TM-899

CCI Report No. 390-111

DESIGN EVALUATION OF VALVE ACTUATOR CAMS
(FERMILAB. RECIPROCATING DESIGN)

PREPARED UNDER FERMILAB SUBCONTRACT NO. 94199
BY CRYOGENIC CONSULTANTS, INC.
ALLENTOWN, PA.

FIGURE 1

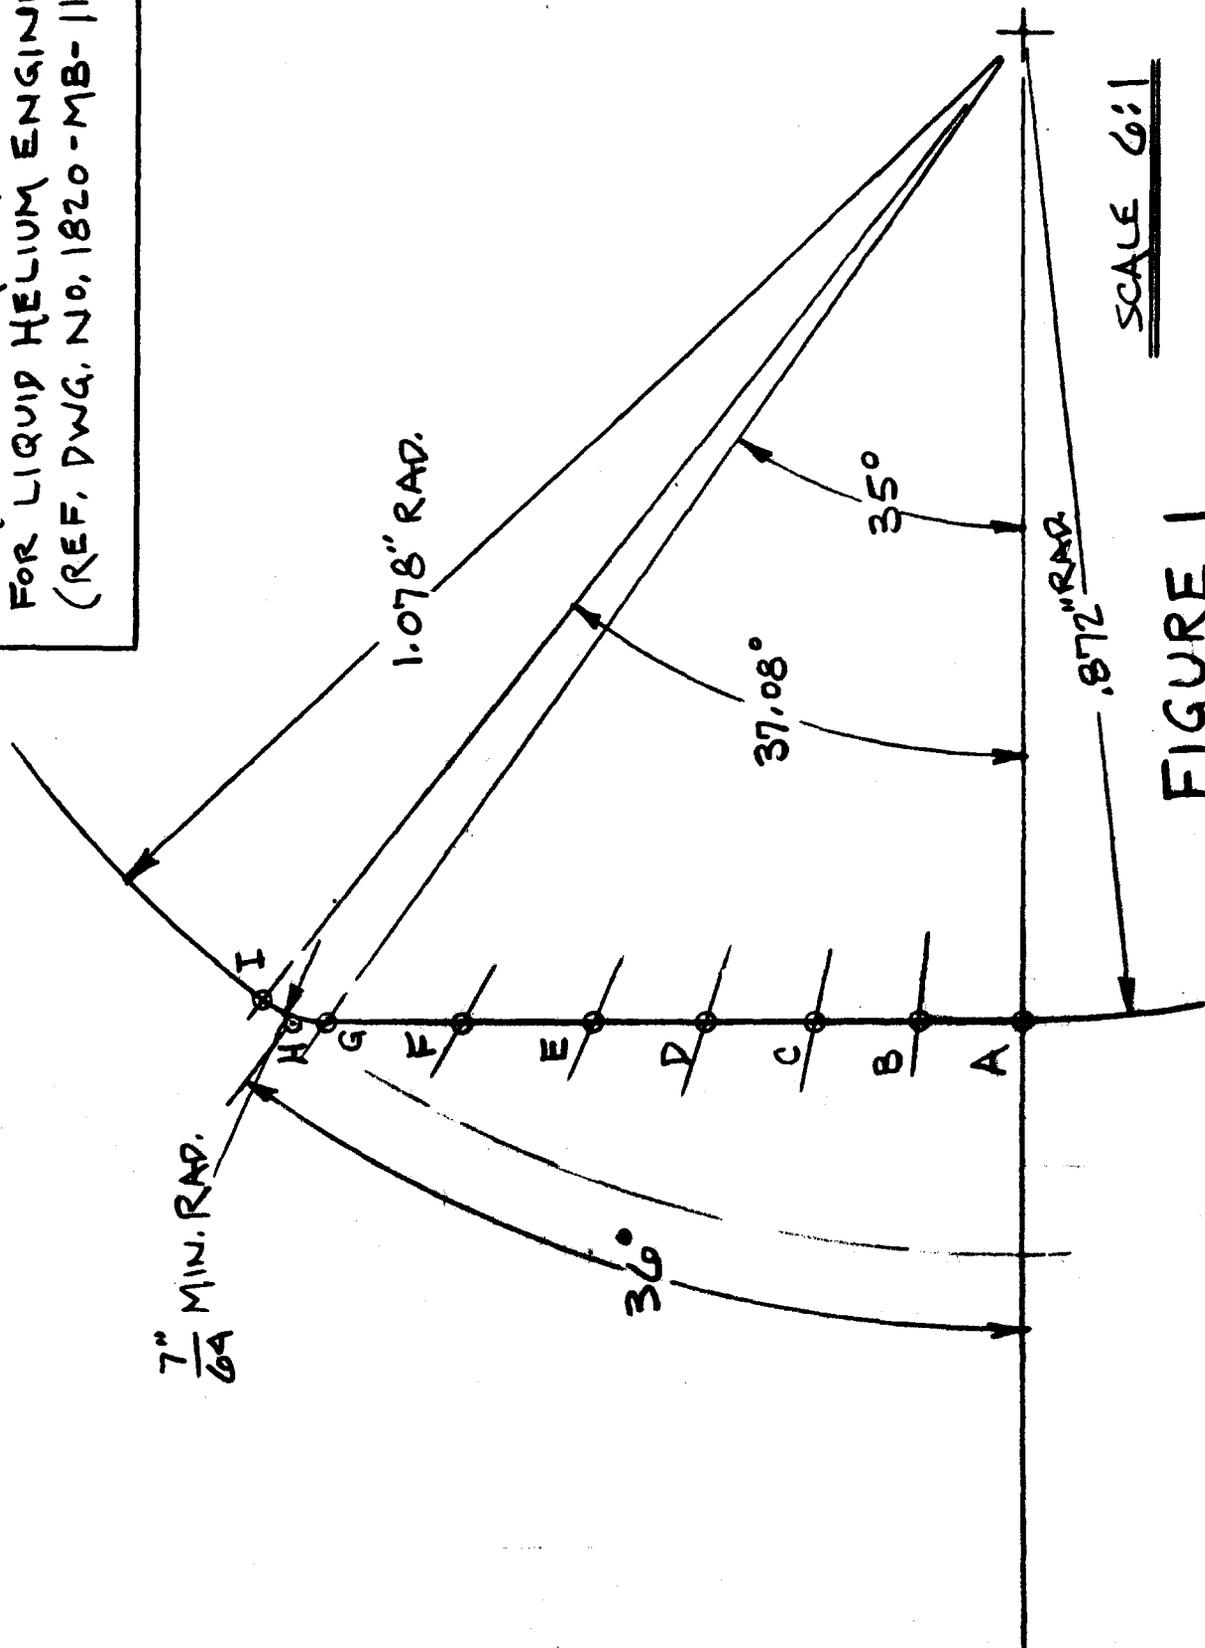
It was concluded that the existing cam profiles with their straight line development from the minor radius to the major radius, together with the small corner blending radius, are not suited for this application. Although low "g" levels are generated during the valve opening cycle, the acceleration is always positive, and at peak opening the cam follower velocity and positive acceleration must be instantaneously opposed by deceleration forces on the order of 114-144 g's. Spring forces incapable of decelerating the follower sufficiently will permit the follower to leave the cam and then slap against the cam causing noise, high shock loads, and premature bearing failure.¹

An enlarged view of the cam profile is shown in Figure 1. For purposes of calculation, the angle from point A to point G (35°) was divided into six equal parts of 5.83333° each.

At 35° the velocity of the cam follower is +3.23216 Ft/sec, and the acceleration is +419.0 Ft/sec. In order to decrease the velocity of the follower to zero in the remaining cam height of 0.01348", the deceleration must be -4650 Ft/sec² or -144g.

FIGURE 2

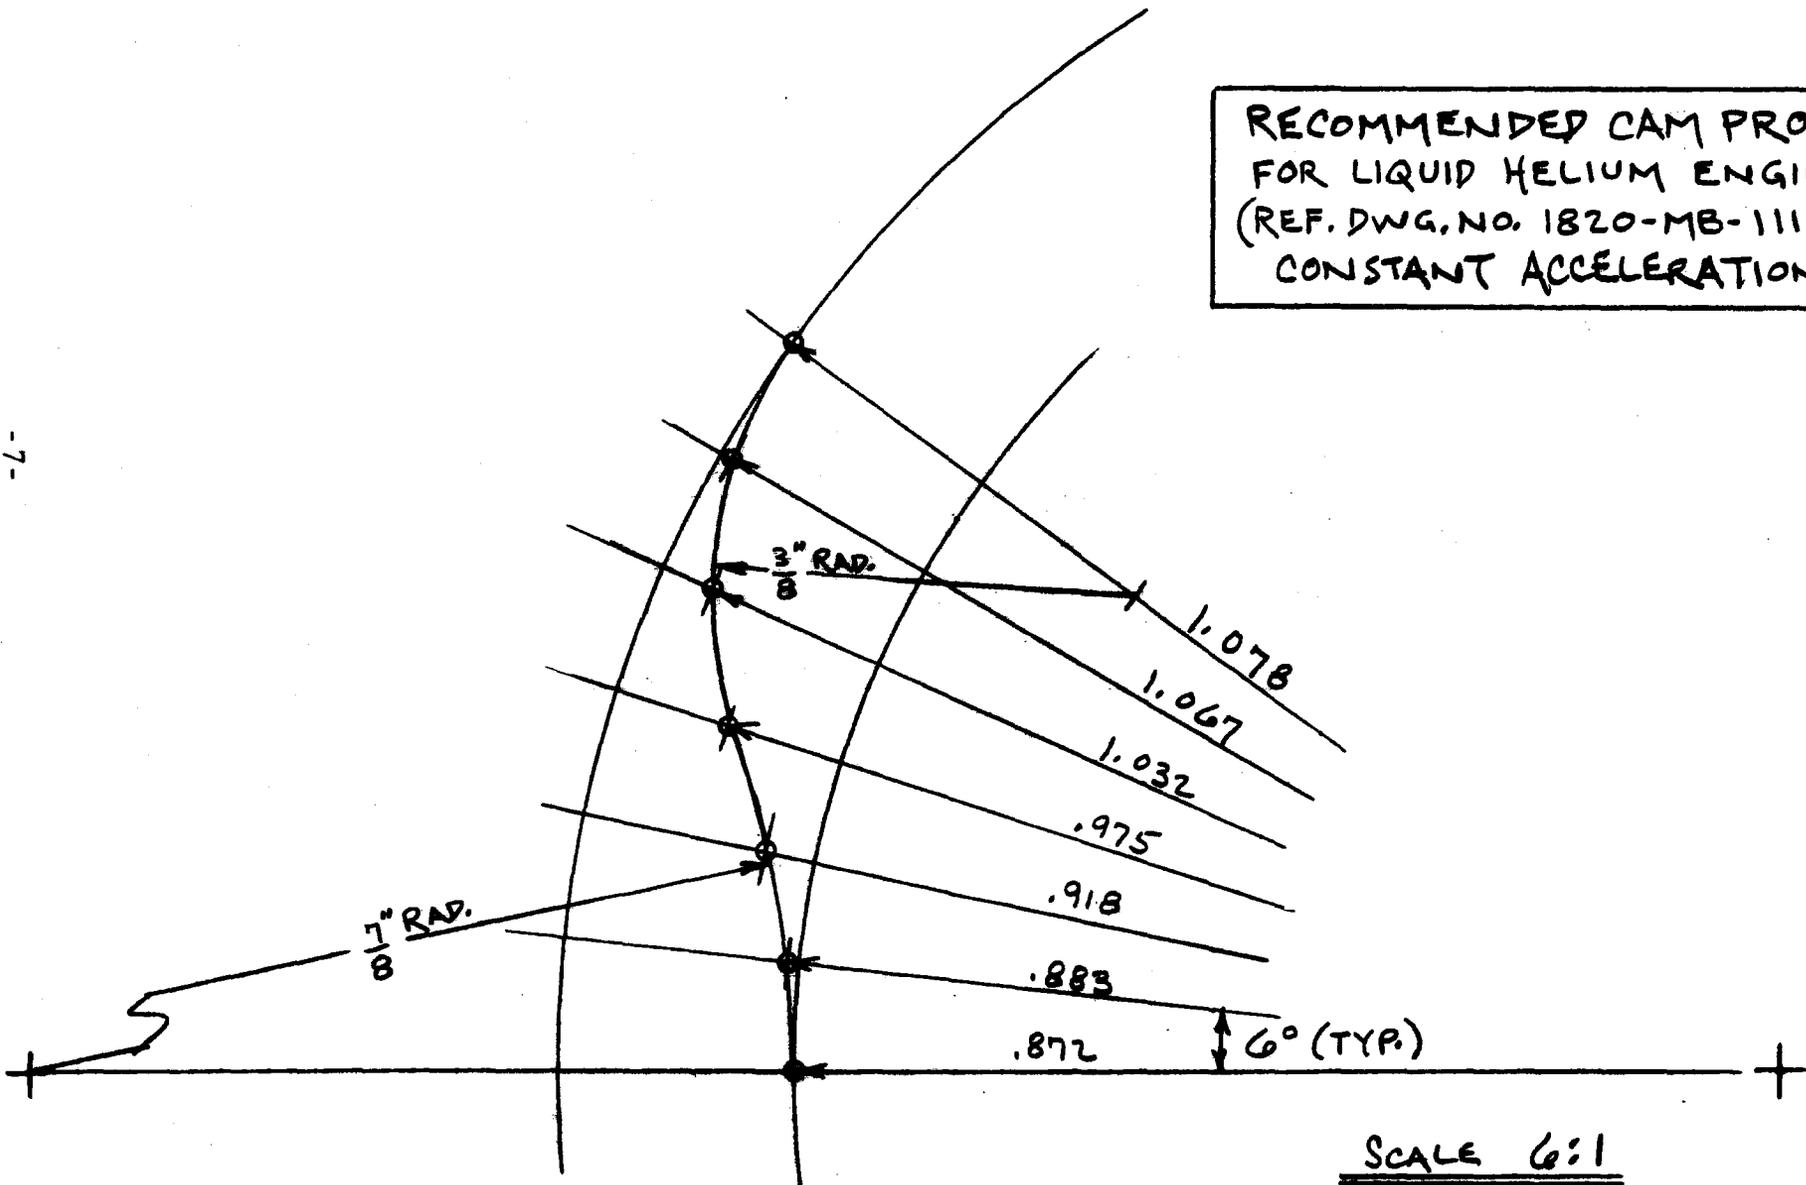
It is desirable to both reduce the deceleration force necessary to restrain the cam follower and eliminate the radial velocity component of the follower when the peak deflection is reached. In order to accomplish this, a constant acceleration - constant deceleration cam is recommended.

This type of cam profile is shown in figure 2. With this cam the peak g-loading is as low as possible for the given lift, speed, and percent rotation to obtain full lift. The radial velocity component of the follower is zero at both the minor and major radii inflection points.

The theoretical cam profile can be approximated almost precisely by using the two radii shown in figure 2. Using the $7/8$ " radius ramp rather than the straight line ramp is optional. More important is that no less than $3/8$ " radius is used to blend the ramp to the major dia.

The spring must be selected to provide an acceleration force of 15 g minimum on the cam follower.

FIGURE 3

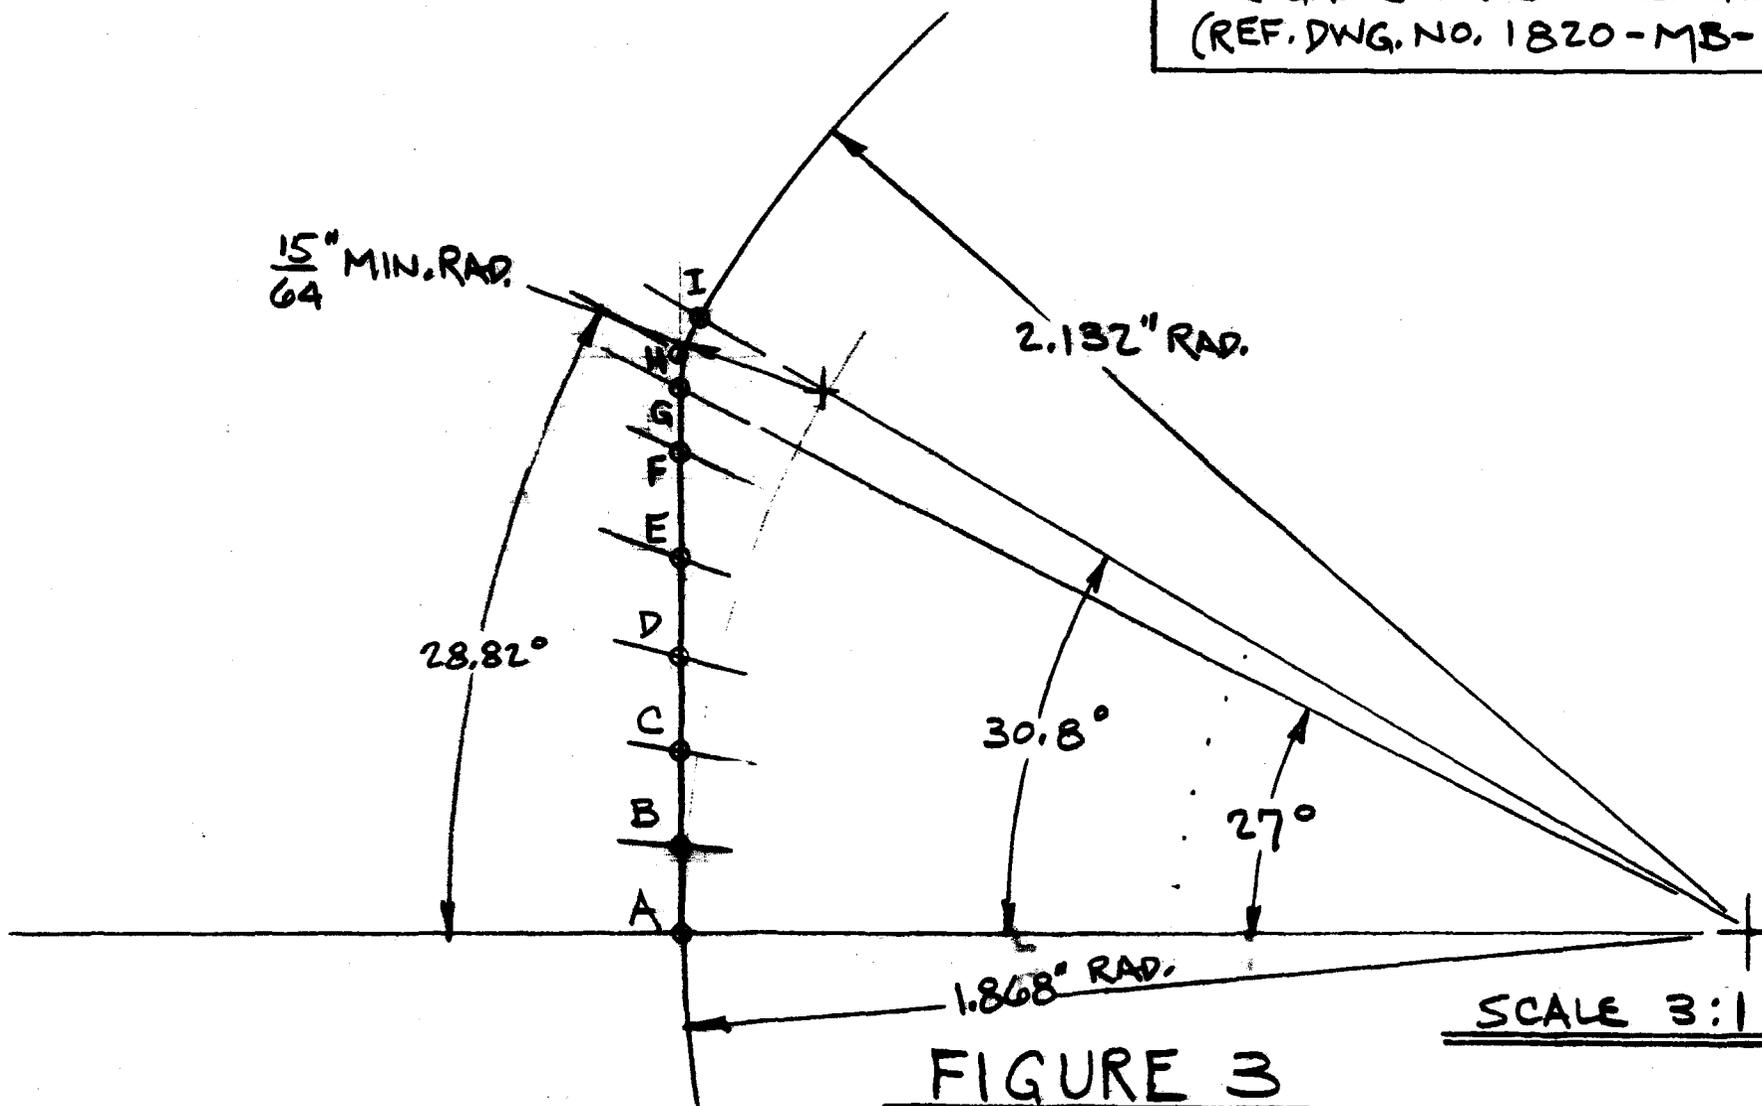
An enlarged view of the cam profile is shown in Figure 3. This cam was analyzed similarly as the cam for the wet engine. For purposes of calculation the angle from point A to point H was divided into 6 equal parts of 4.80266° each.

At 27° the velocity of the cam follower is $+4.66109 \text{ Ft/sec}$ and the acceleration is $+710.31 \text{ Ft/sec}^2$. In order to decrease the velocity of the follower to zero in the remaining cam height of $.03549''$, the deceleration must be -3673 Ft/sec^2 or -114 g .

FIGURE 4

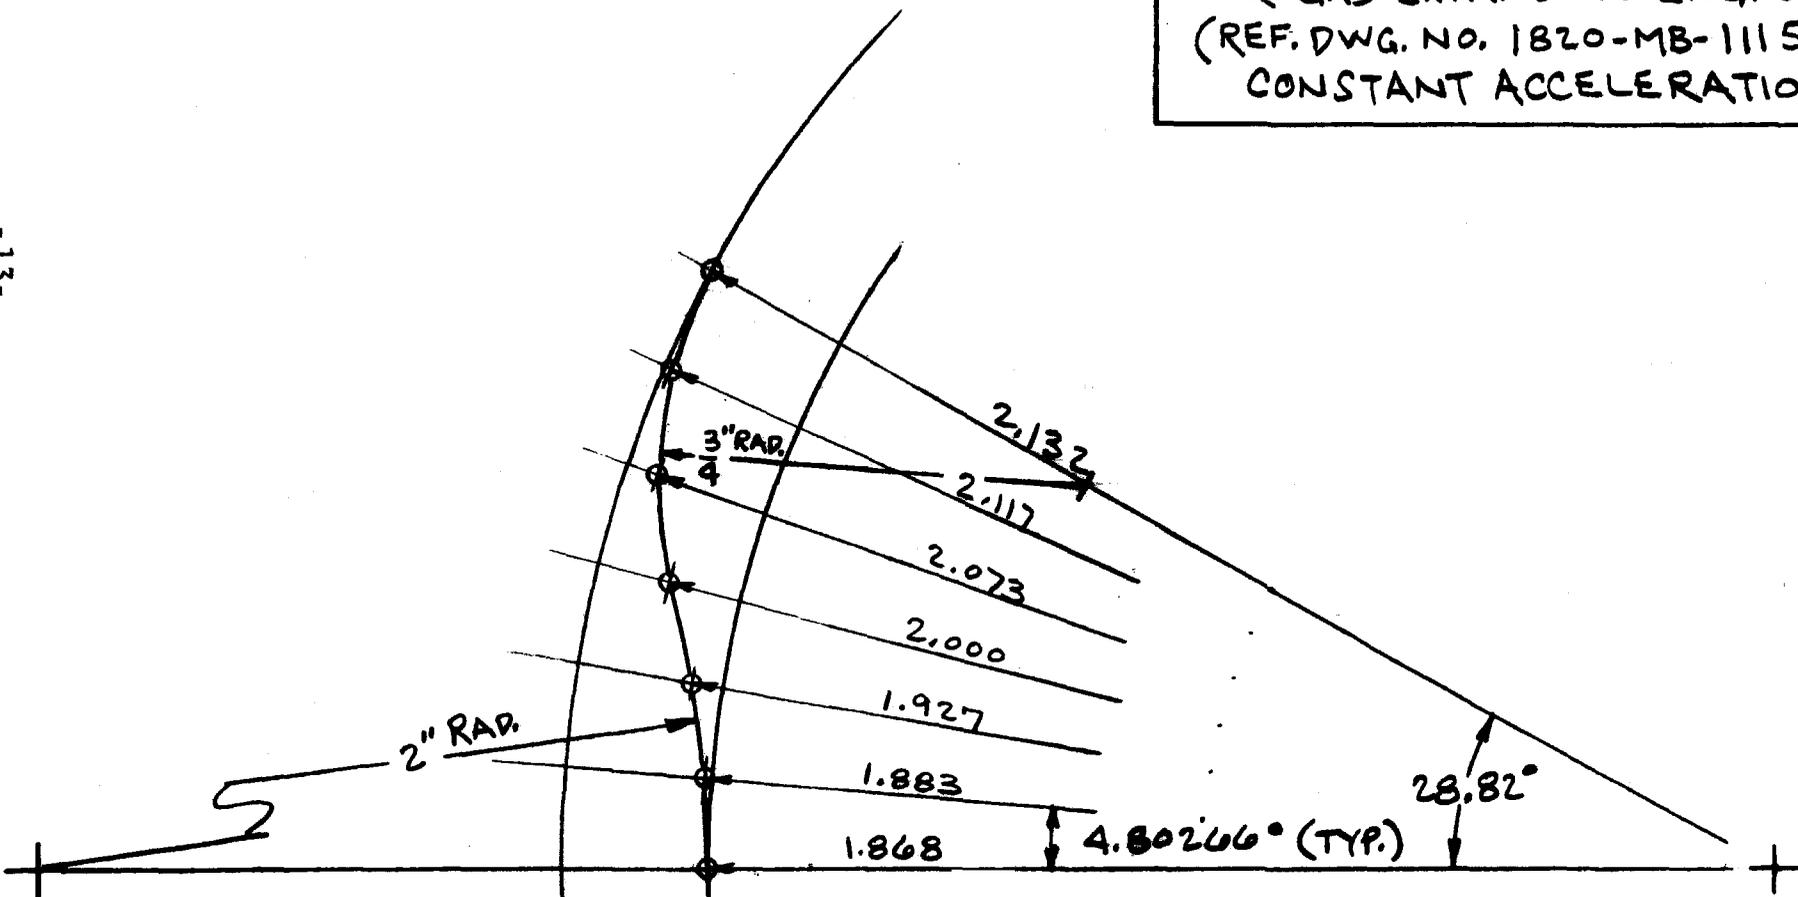
A constant acceleration cam profile for the gas engine is shown in figure 4.

The theoretical profile can be approximated by using the two radii shown. Again, the curved (2" Rad.) ramp is optional but the blend radius of 3/4" minimum must be used.

The spring selected must provide a deceleration force of 30 g minimum on the cam follower.
